Subject: 15 204 – Noncompliance - A-Pillar Trim Replacement
A-Pillar Trim Replacement - Additional Population

Models: 2002-2008 Saab 9-5
VIN Range: 23000252 - 83512093

MODIFICATION INSTRUCTION

Replacing the A-pillar trim

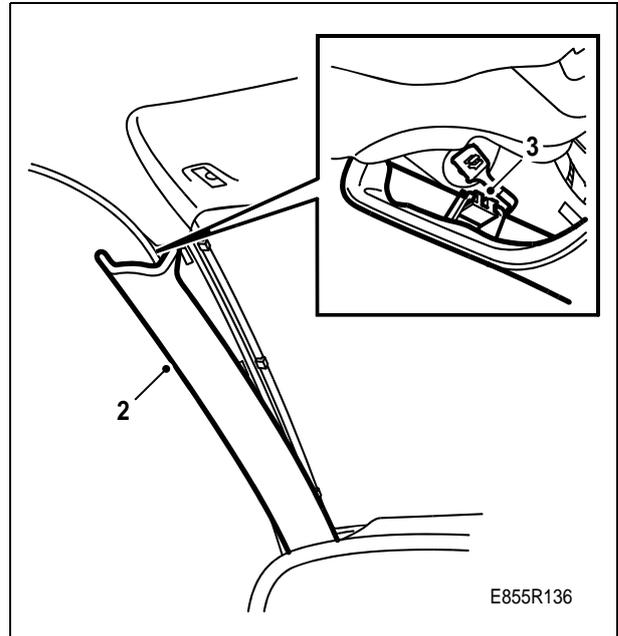
The A-pillar trim does not fulfil the FMVSS 201U legal requirement with regard to head protection.

- 12842651 A-pillar trim (left) (M02-05)
- 12842652 A-pillar trim (right) (M02-05)
- 12842653 A-pillar trim (left) (M06-08)
- 12842654 A-pillar trim (right) (M06-08)

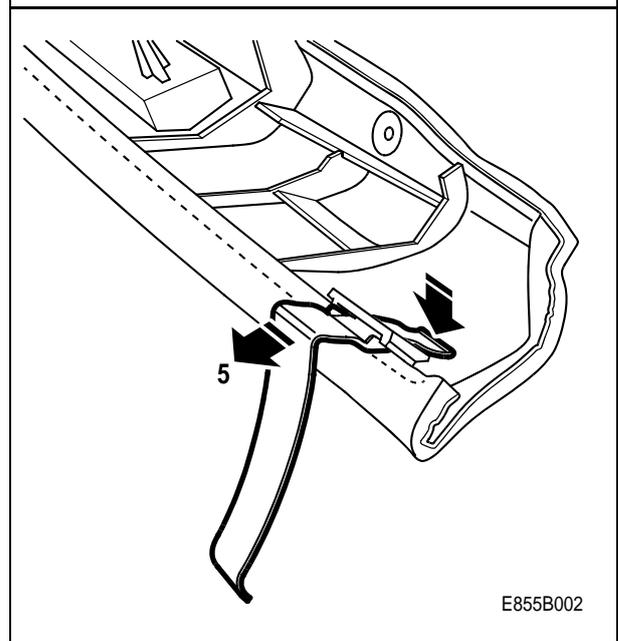
- 1 Remove the door weatherstrip from the A-pillar.
- 2 Pull the A-pillar trim loose (fastened with clips).
- 3 Remove the top clip from the A-pillar using diagonal cutting pliers.
- 4 Lift away the trim.

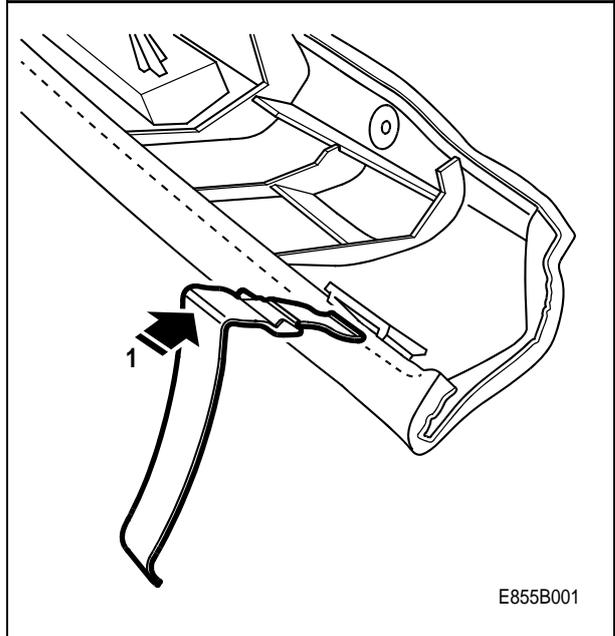
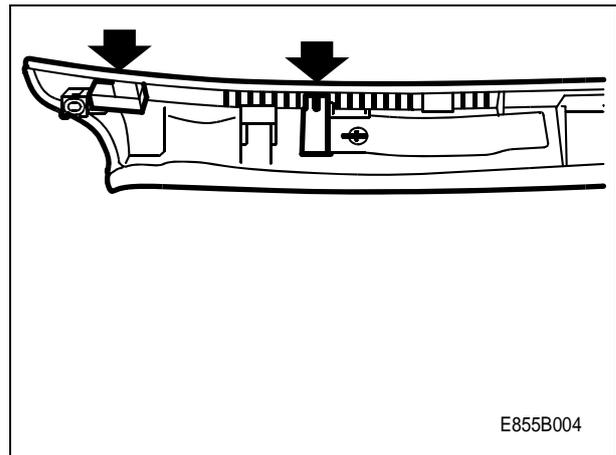
Take care to avoid damaging or loosening the energy absorbers. A damaged or loosened energy absorber must not be refitted. Replace the A-pillar trim where appropriate. A damaged energy absorber could provide reduced protection to the head in the event of impact.

- 1 Refit the parking ticket holder, if one was fitted, and fit the new trim.

- 2 Fit the lower section of the new trim in place.
- 3 Press in the new trim at all 3 clips.
- 4 Fit the door weatherstrip.
